Subject: Collin County Healthcare Facility, Parking Garage, and Medical Examiners  
Request for Change (PCO) No. 040; RFI #142 PG Civil and Plumbing Storm Sewer Tie-in

**Request for Change**

## RFI #142: PG- Plumbing and Civil Storm Sewer Tie-in

**This CO is associated with RFI#142 changes**

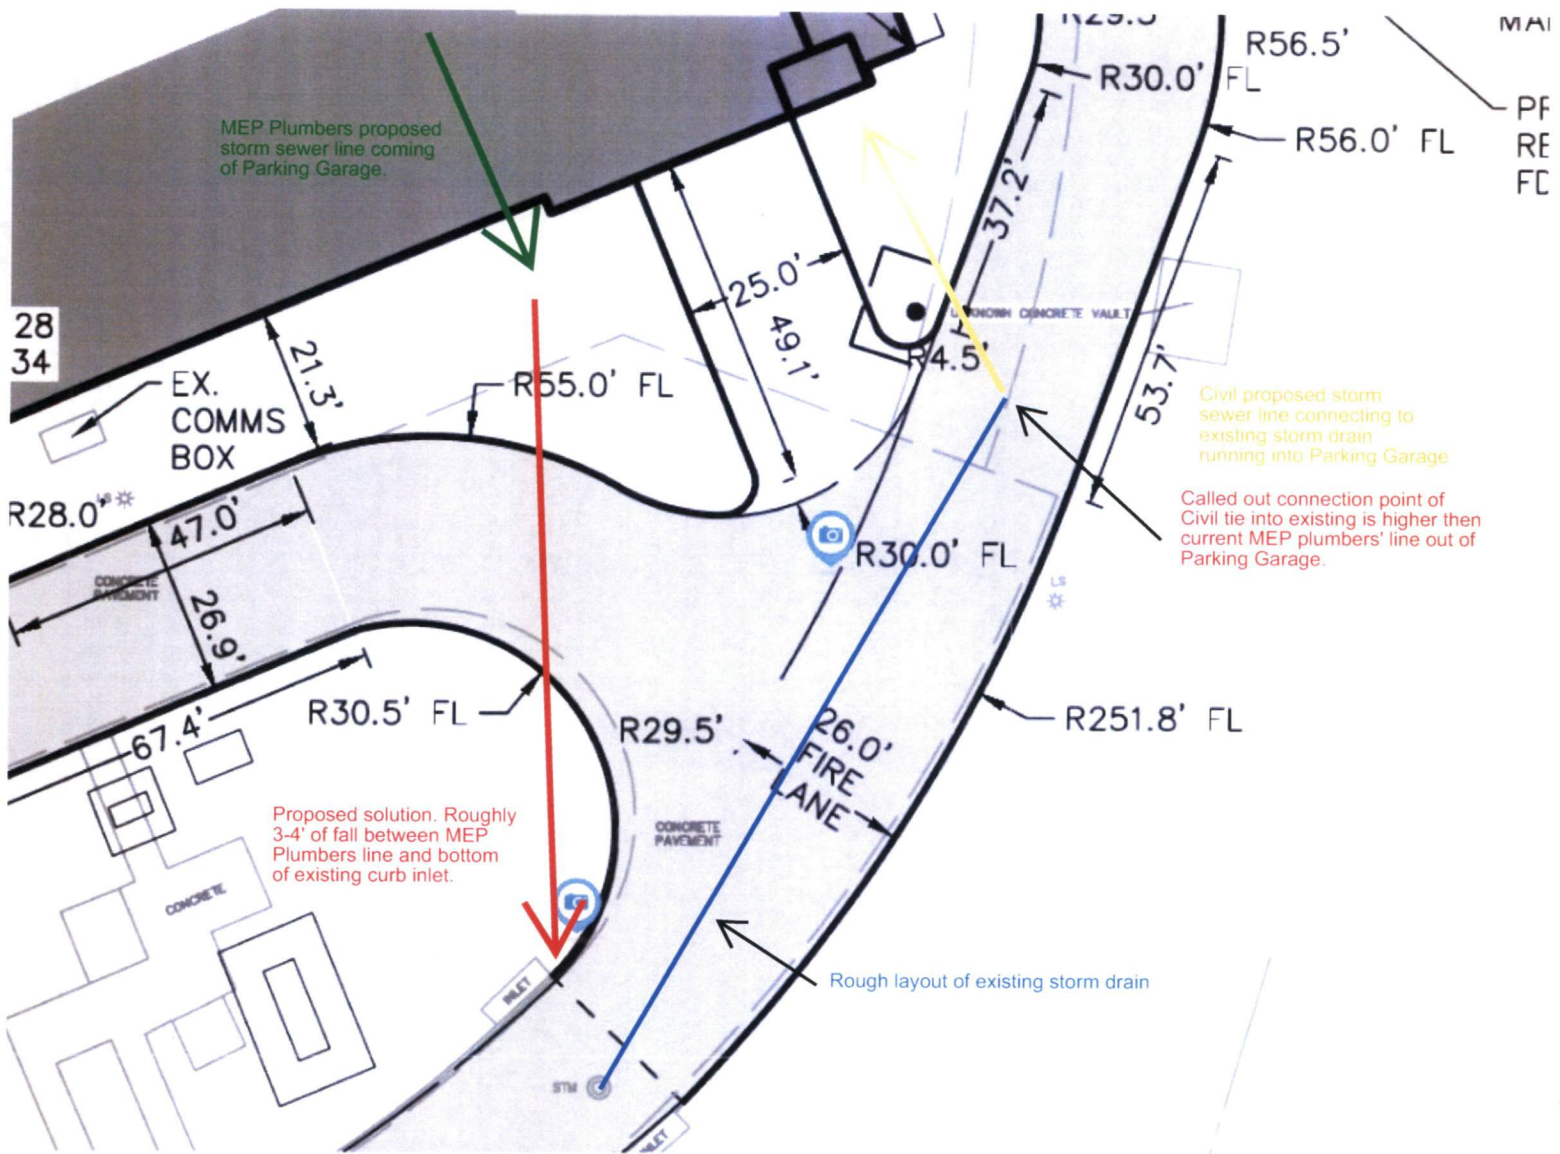
18" RCP	105	LF	68.57	7,875.00
Excavate and Prep box for Connection	1	EA	450.00	1,125.00
Wall Saw Existing Storm Drain Structure	1	EA	2,200.00	2,875.00
Join PVC Stub w/ Collar	1	EA	470.00	1,145.00
